State of Kansas) SS We, Baughman Company, P.A., Surveyors in Sedgwick County) aforesaid County and State do hereby certify that we have surveyed and platted "LARK 6TH ADDITION", Wichita, Sedgwick County, Kansas and that the accompanying plat is a true and correct exhibit of the property surveyed, described as and being a replat of Lots 1, 2, 3, 4, 5, 6, 7, 8, and 9, Block C, Lark Addition, Wichita, Sedgwick County, Kansas, together with all of Dora Ct. lying within said Block C, together with all of Reserve "C" as platted in said Lark Addition, together with a replat of a part of Reserve "A", Lark 4th Addition, Wichita, Sedgwick County, Kansas, and together with a tract of land in the in the NW1/4 of Sec. 31, Twp. 27-S, R-1-W of the 6th P.M., Sedgwick County, Kansas, described as follows:

Re: S/D 97-39 - Final Plat of LARK 6TH ADDITION

Re: S/D 97-39 - Final Plat of LARK 6TH ADDITION

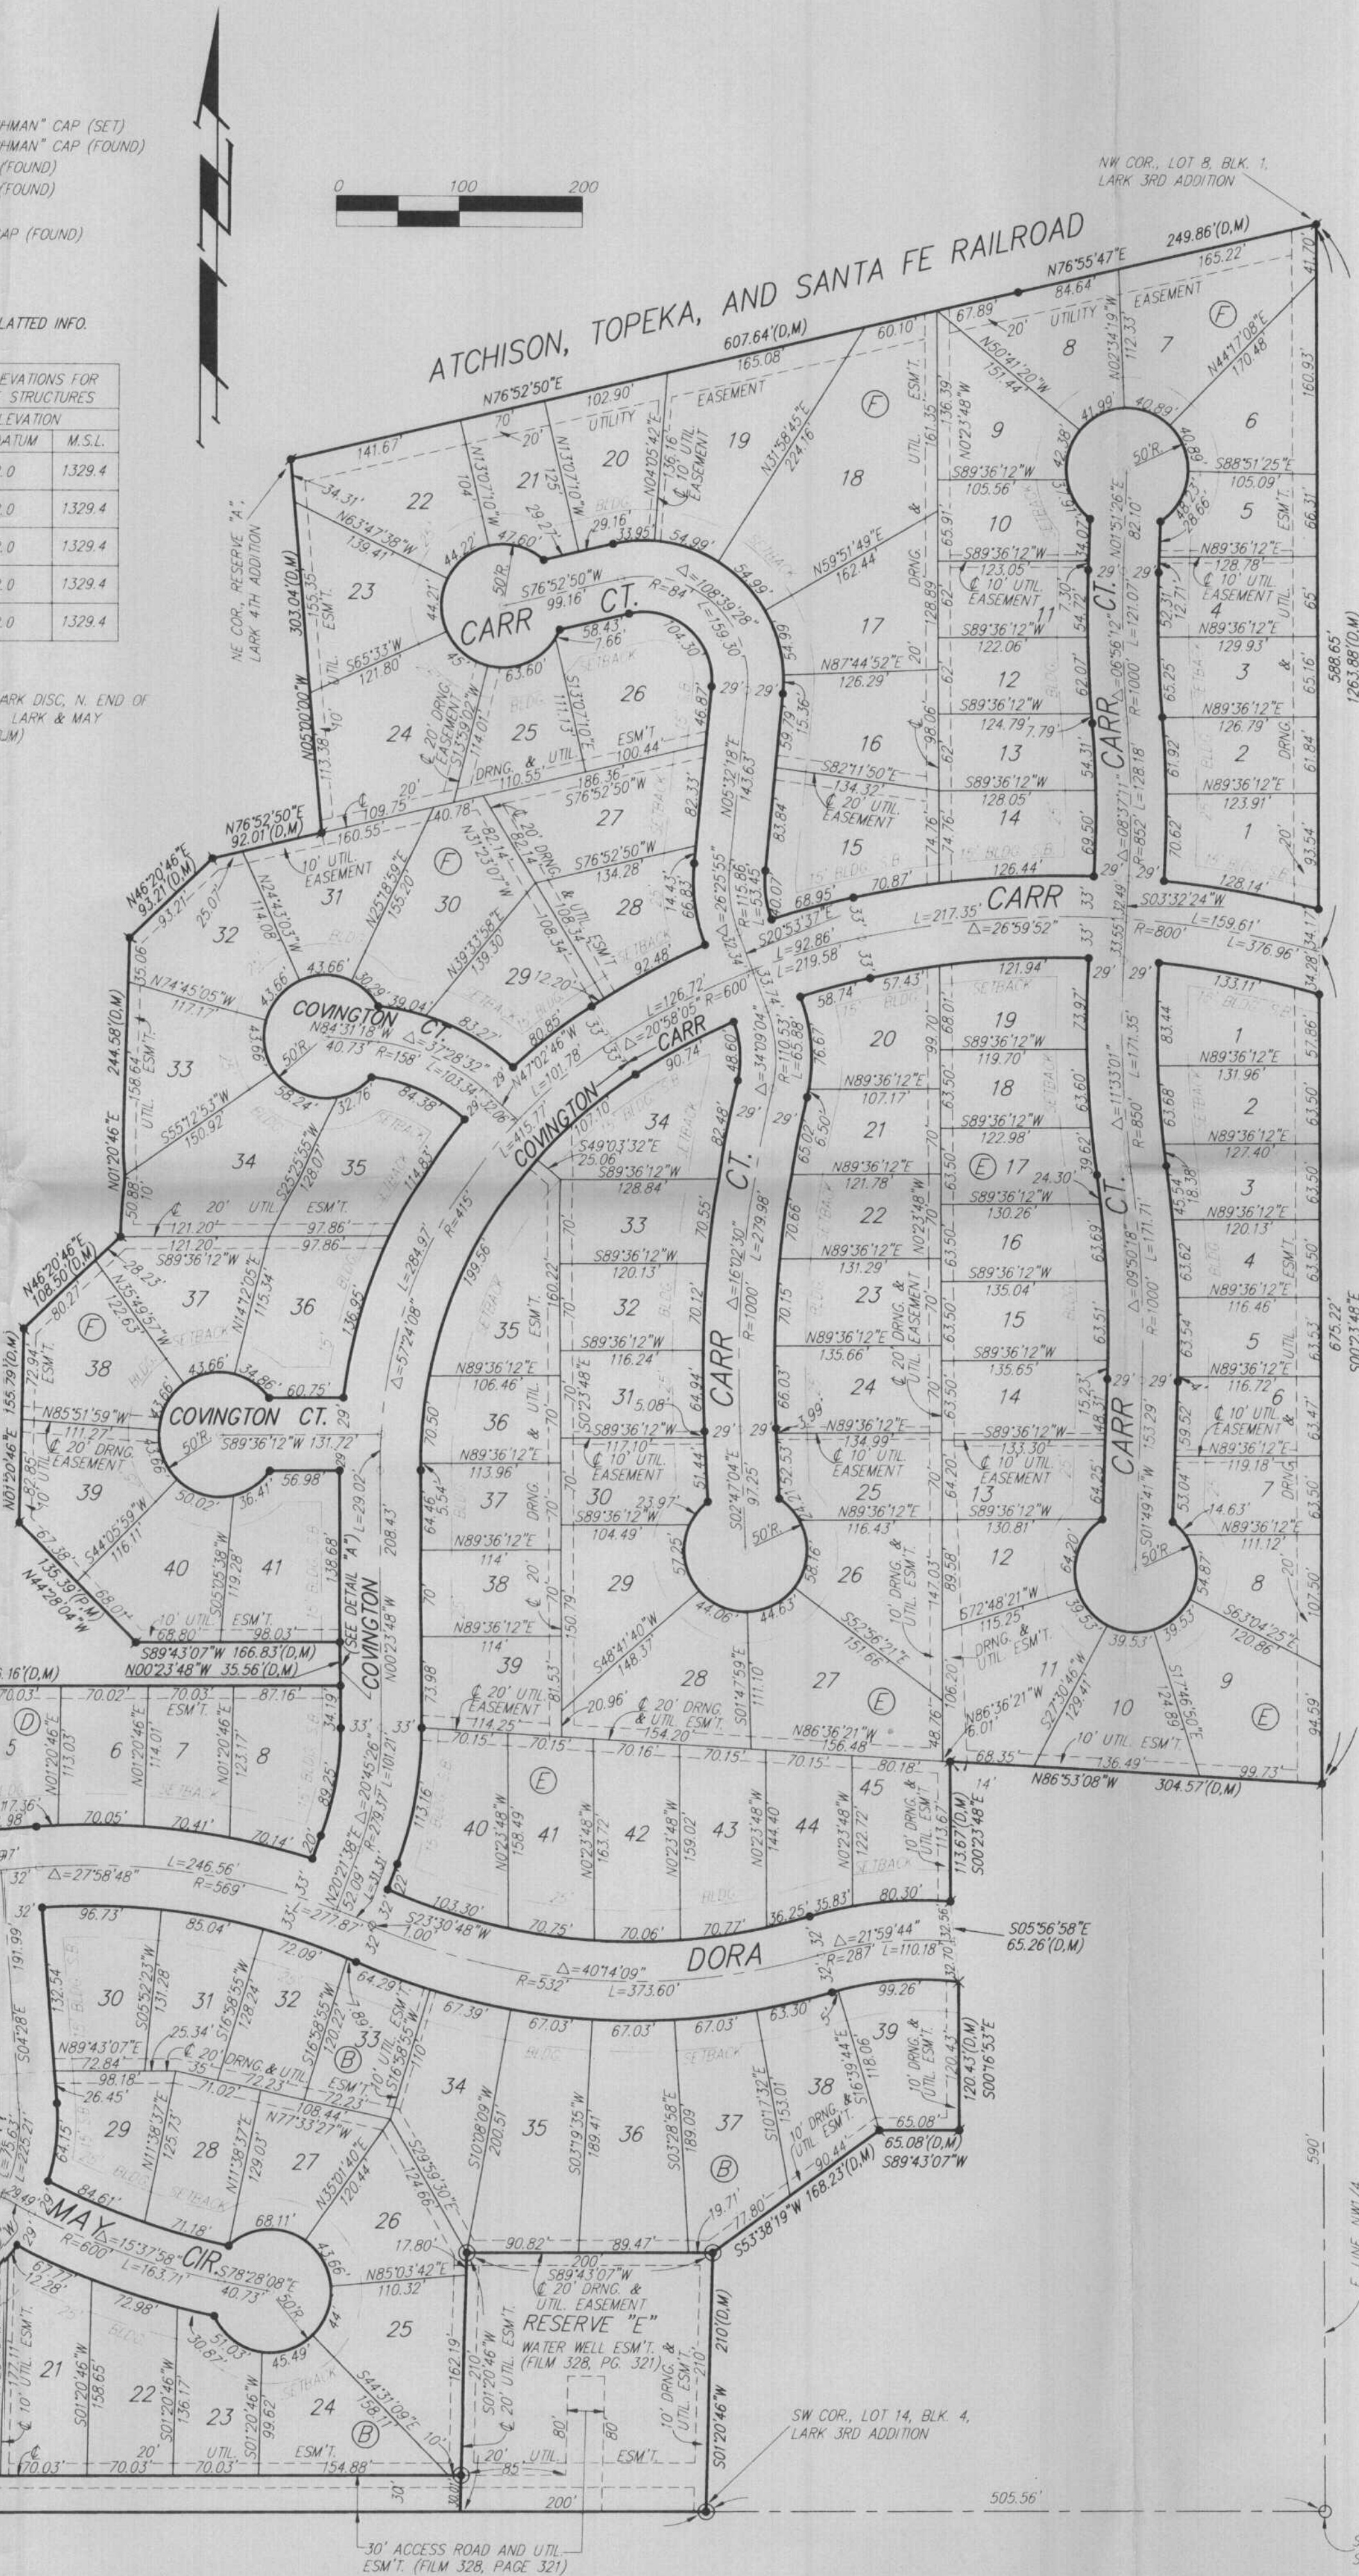
- C. The applicant shall guarantee the paving of the proposed interior streets. Engineering needs to comment if any improvements or guarantees are needed to 119th Street

- D. Sidewalks should be provided along Dora, May / Cardington and Covington / Carr Streets.
- E. The applicant shall guarantee the construction of any drainage improvements required by the platting of this property, including storm sewers.

- H. Representatives from the City Fire Department and / or OCI need to comment on the acceptability of proposed street names.
- I. City Engineering indicates the applicant's drainage plan has been approved. Drainage improvements will be guaranteed. Minimum pad elevation calculations need to be verified.

- P. Recording of the plat within thirty (30) days after approval by the City Council.
- Q. A typo should be corrected in the first sentence of the platter's text regarding reserves and easements, and in the last sentence of the legal description section.

- R. 119th Street should be identified.
